NO.	REVISION/DESCRIPTION	BY	DATE
1	ISSUED FOR ADDENDUM 2 CEA	CEA	2015.10.15
0	ISSUED FOR BID	CEA	2015.09.25

PROJECT:
FPS TRAINING
CARPET & BLIND RENO
2546 McPHILLIPS STREET

SHEET TITLE:
KEY PLAN/AREA OF WORK

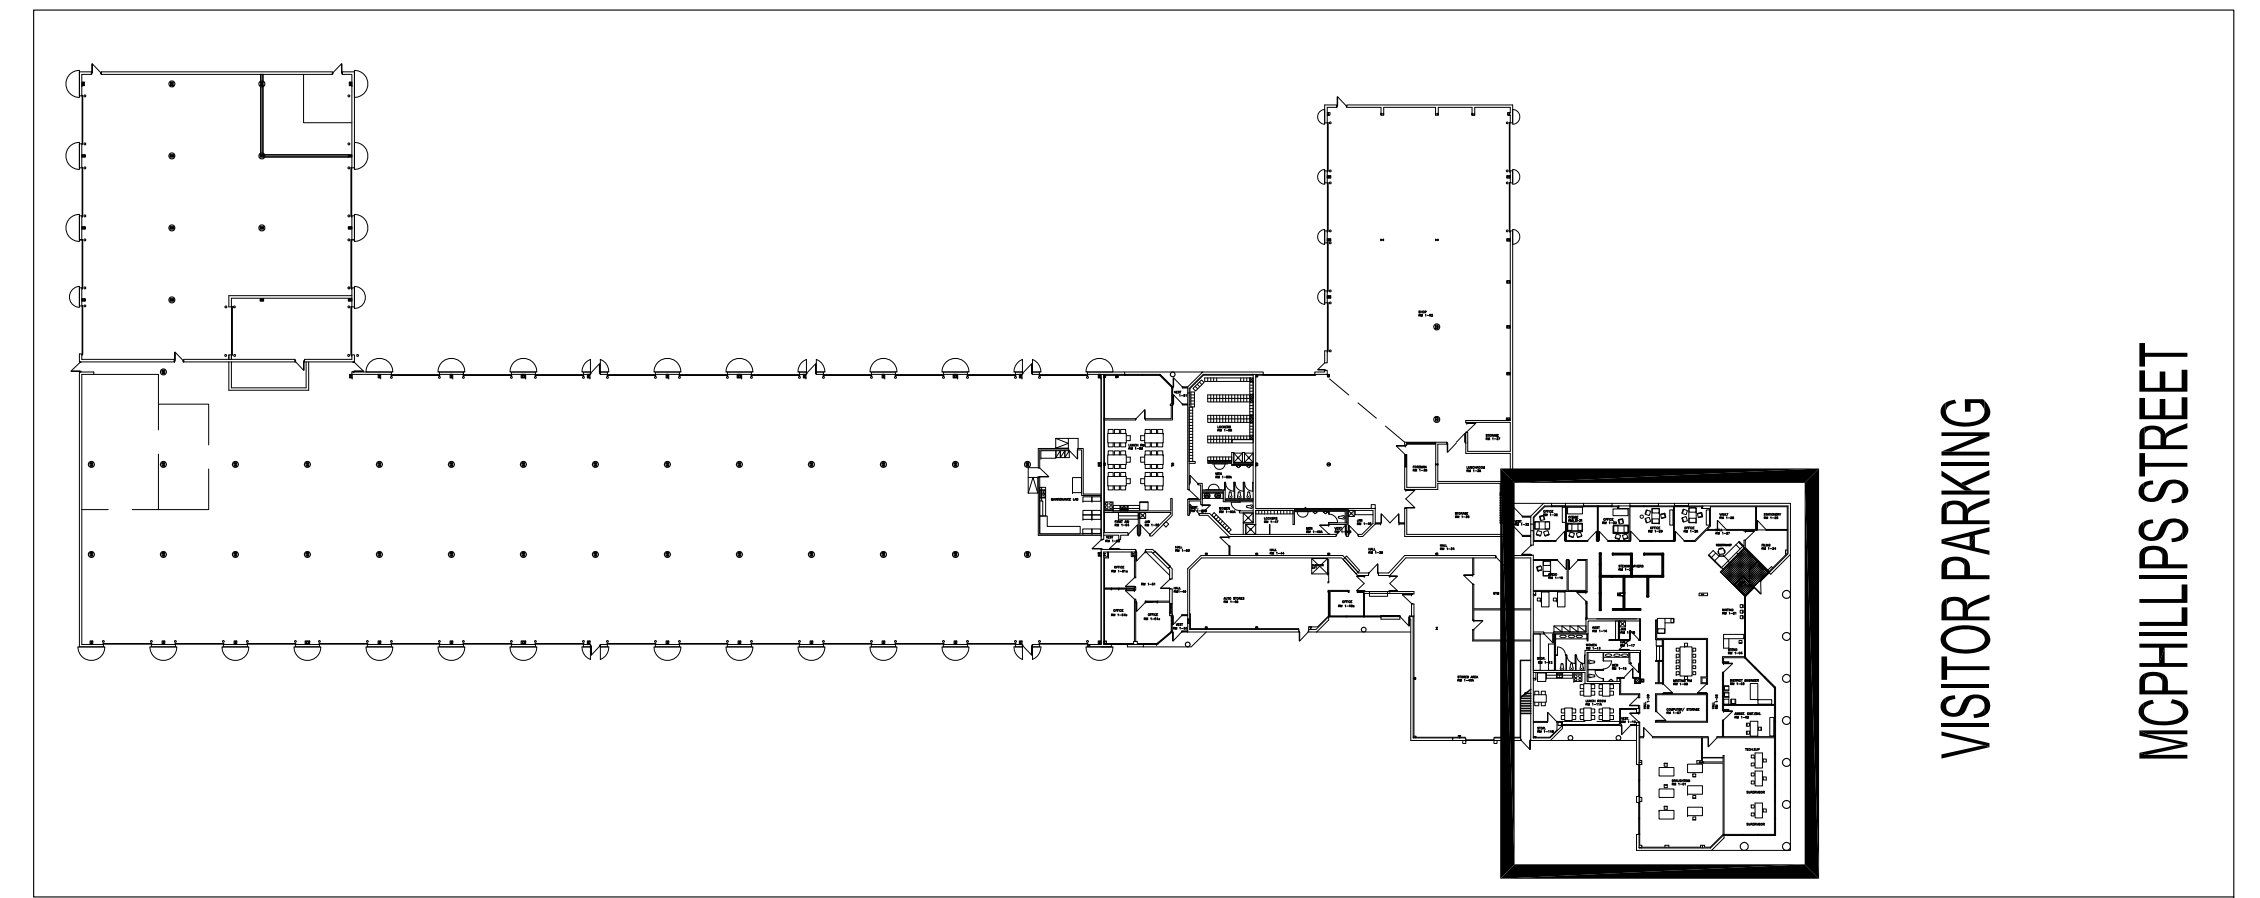
1 CHANGE TO AREA OF WORK. ROOMS 1-12, 1-25, AND 1-26 REMOVED.
